FLOOD RISK ASSESSMENT ADDENDUM

# Mead Realisations Ltd

Lynchmead Farm, Weston-Super-Mare

Flood Risk Assessment

PRELIMINARY SURFACE WATER DRAINAGE LAYOUT - SHEET 1

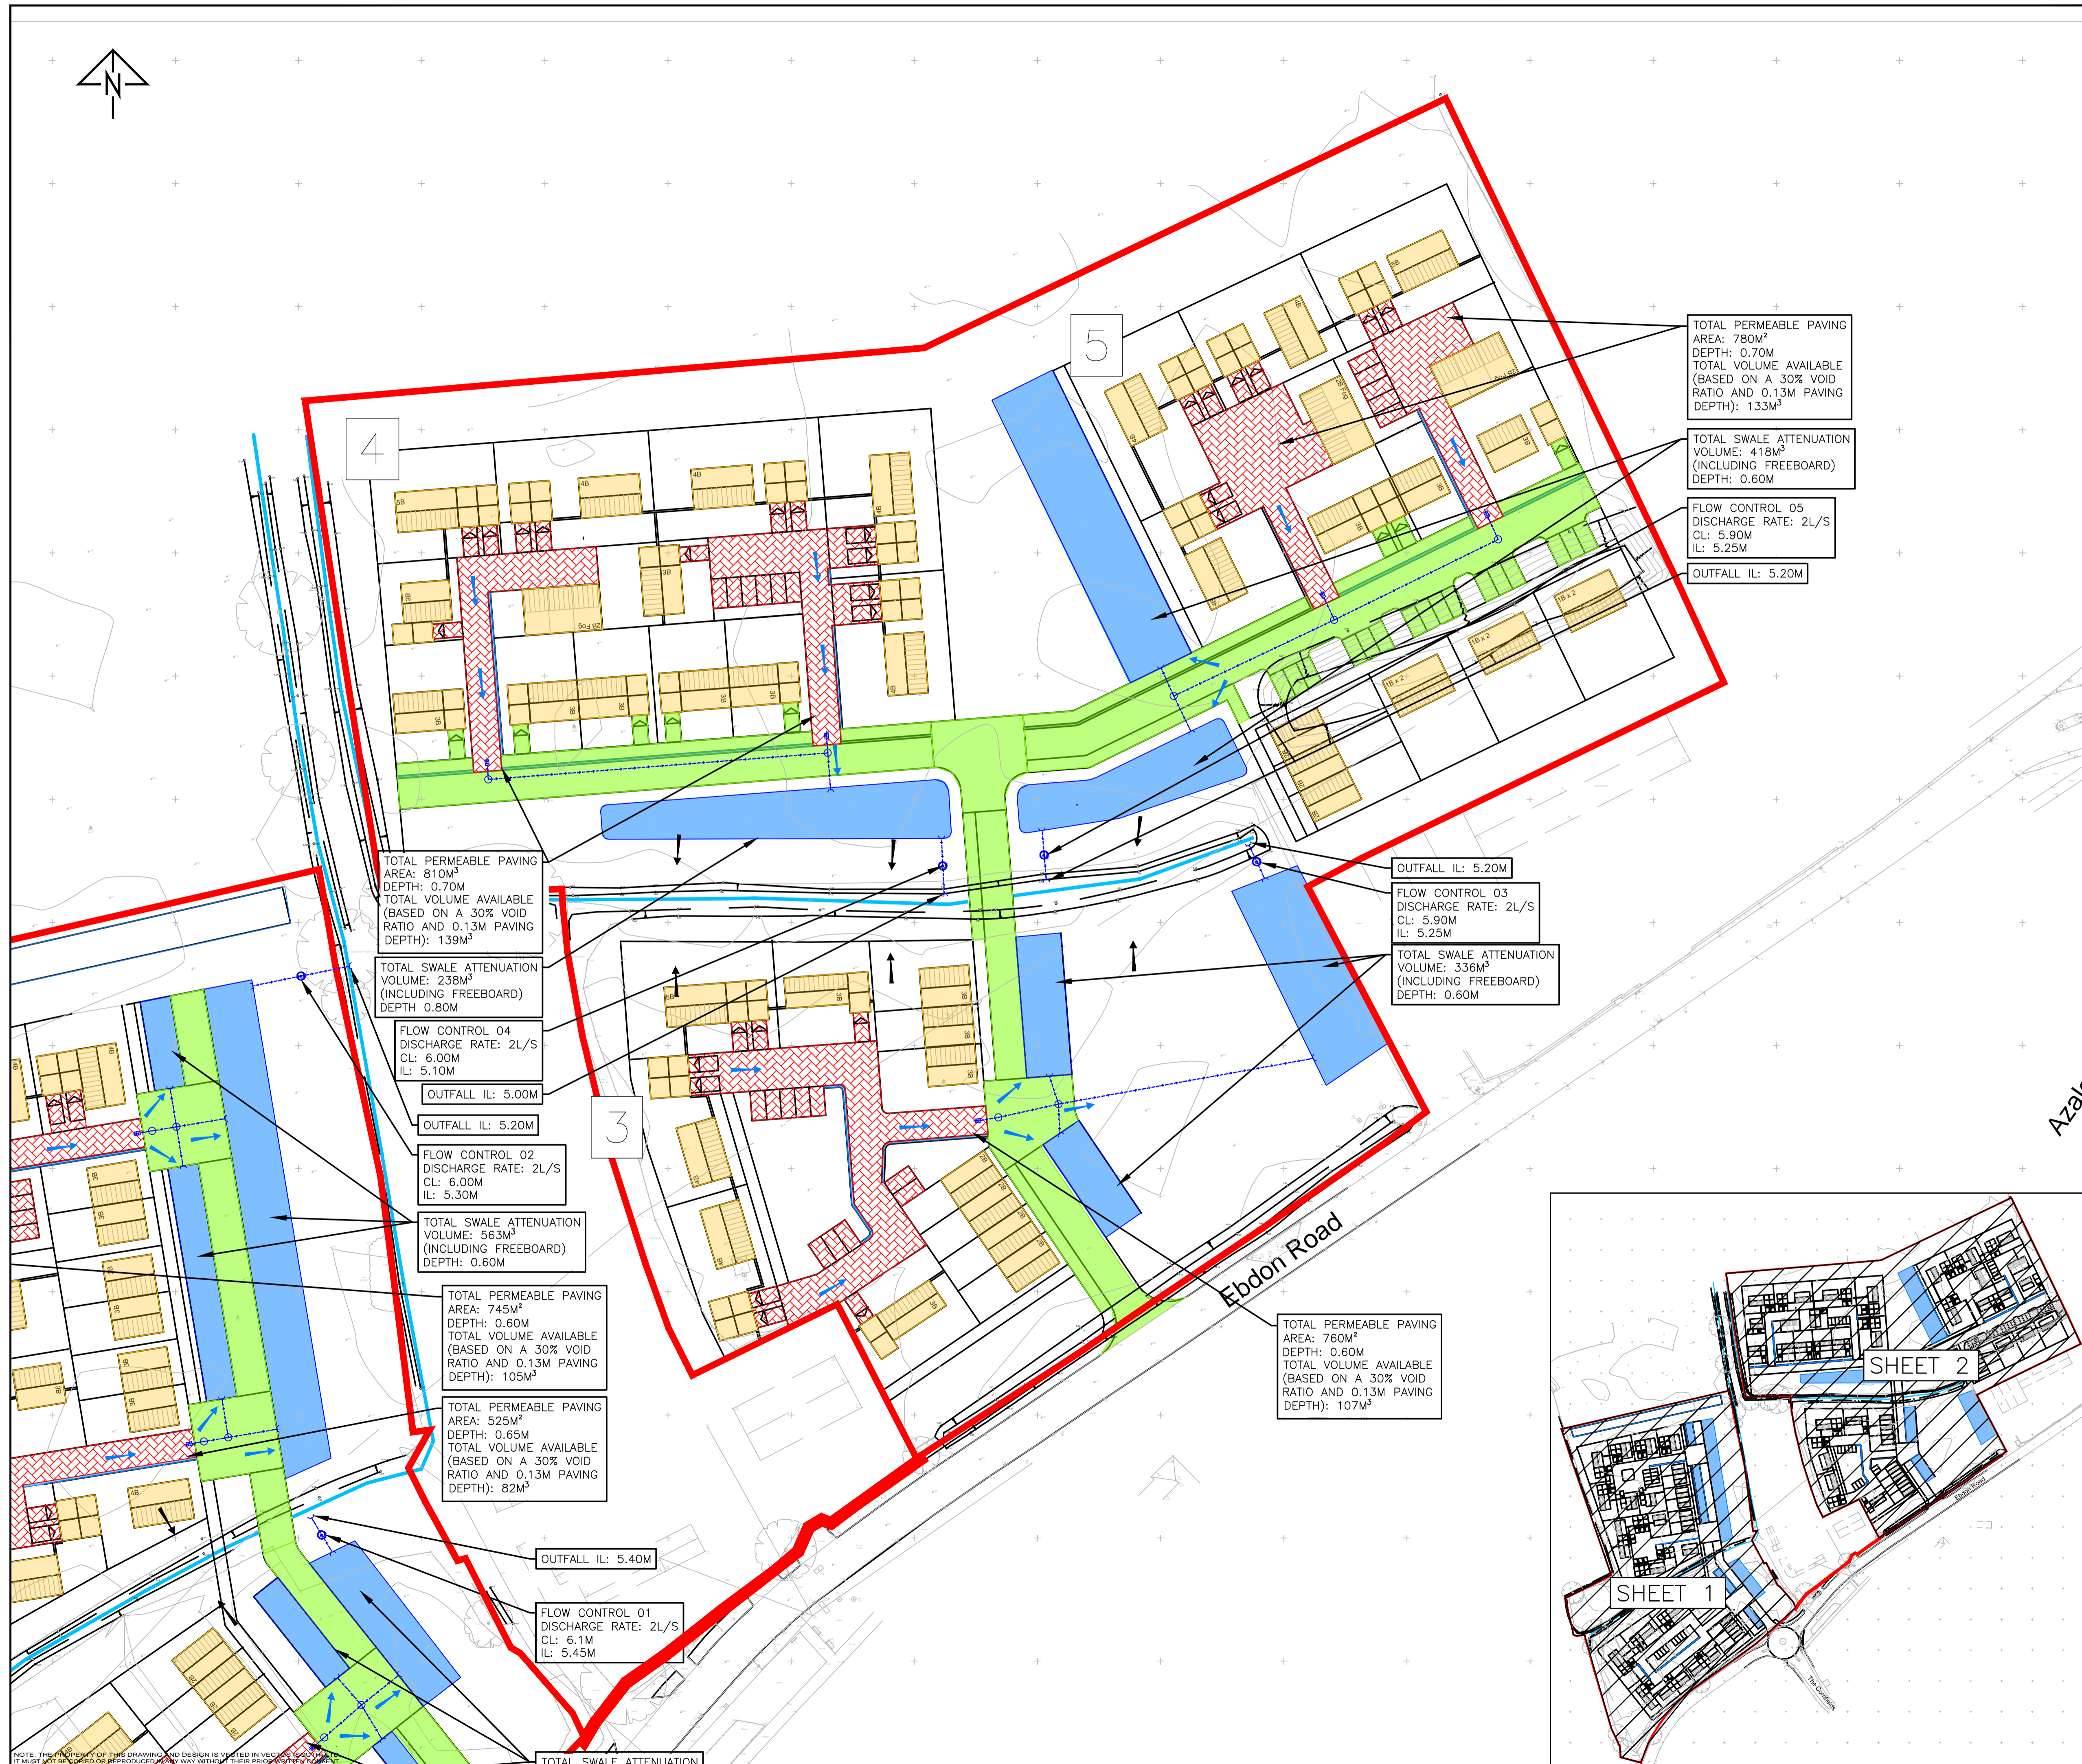
- 2.2 LLFA Comment: Plan(s) of a proposed surface water drainage strategy indicating the proposed surface water drainage features, proposed attenuation volumes, dimensions, indicative cover and invert levels and a suitable outfall location.**

- 2.5 LLFA Comment: A contributing catchment plan demonstrating the impermeable area which is attenuated by each permeable paving and swale, taking into consideration creep in the contributing areas.**

- 2.3 Vectos Response: A preliminary surface water drainage layout has been prepared to provide further information requested by the LLFA (see Appendix A). It should be noted that this is an outline application and the information presented is preliminary and indicative.

- 2.4 The preliminary surface water drainage layout shows the how SuDS features including permeable paving, swales and attenuation basins could be integrated into the site.

- 2.6 Vectos Response: The preliminary surface water drainage layout identifies impermeable areas, split into 5 parcels, which will be attenuated by swales and permeable paving. Attenuation volumes have also been shown on this layout (see appendix A). A 10% urban creep factor has been applied to the impermeable development areas.
